Access Compliance Report Public Rights-of-Way (Curb Ramps)

Main Street: LOST_CANYON Cross Street: ROLLING_RIDGE Location: SW

ADA ID: RPRK211019142018 Ramp Type: Type 4 - Parallel Initial Pass/Fail: Fail Overall Compliance: No Severity Score: 60

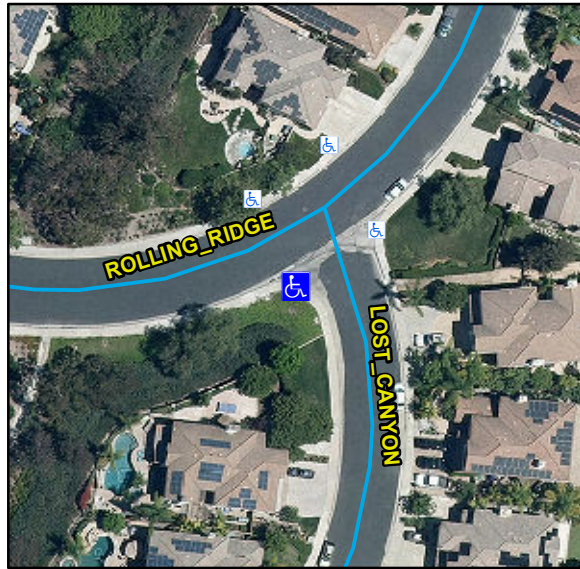
Compliance	Description	Data	Compliance	Description	Data
N/A	Ramp Length LT (in)	126	N/A	Ramp Length RT (in)	112
Yes	Ramp Width LT (in)	54	Yes	Ramp Width RT (in)	54
No	Ramp Run Slope LT (%)	14.1	Yes	Ramp Run Slope RT (%)	5.5
No	Ramp Cross Slope LT (%)	12.2	No	Ramp Cross Slope RT (%)	9.7
N/A	Landing Present	N/A	N/A	DWS Provided	N/A
N/A	Landing Length (in)	N/A	N/A	DWS Contrast	N/A
N/A	Landing Width (in)	N/A	N/A	DWS Length (in)	N/A
N/A	Landing Run Slope (%)	N/A	N/A	DWS Full Width	N/A
N/A	Landing Cross Slope (%)	N/A		DWS Offset Type	N/A
N/A	Landing Movement Obstructed?	N/A	N/A	DWS Offset Left (in)	N/A
	Landing Movement Type	N/A	N/A	DWS Offset Right (in)	N/A
N/A	Landing Shared	N/A			
N/A	Clear Space	Yes			
N/A	Clear Space To Crosswalk (in)	N/A			
N/A	Marked Crosswalk 1	No	N/A	Marked Crosswalk 2	No
	Crossing 1 Direction	E		Crossing 2 Direction	N
N/A	Marked Crosswalk 1 Width (in)	N/A		Marked Crosswalk 2 Width (in)	N/A

N/A	Ramp Inside Crosswalk 1	N/A	N/A	Ramp Inside Crosswalk 2	N/A
	Crossing 1 Slope (%)	7.1		Crossing 2 Slope (%)	3.4
	Crossing 1 Cross Slope (%)	6.6		Crossing 2 Cross Slope (%)	6.3
N/A	Gutter Ponding	N/A	N/A	Curb Slope	3.9
Yes	Gutter Lip Height (in)	0		Road Run Slope (%)	7.7
N/A	Gutter Run Slope (%)	N/A		Road Cross Slope (%)	4.3
N/A	Gutter Cross Slope (%)	N/A	No	Perpendicular Joint Present	No
Yes	Overall Surface Condition	Acceptable			
	Cross Gutter Present?	Yes		Spandrel Present?	Yes
	Replace Cross Gutter?	No		Replace Spandrel?	No

Remove & Replace Curb Ramp With Two New Directional Ramps or Equivalent.

R204.3, R304.3.2, R304.5.3, STD 1115
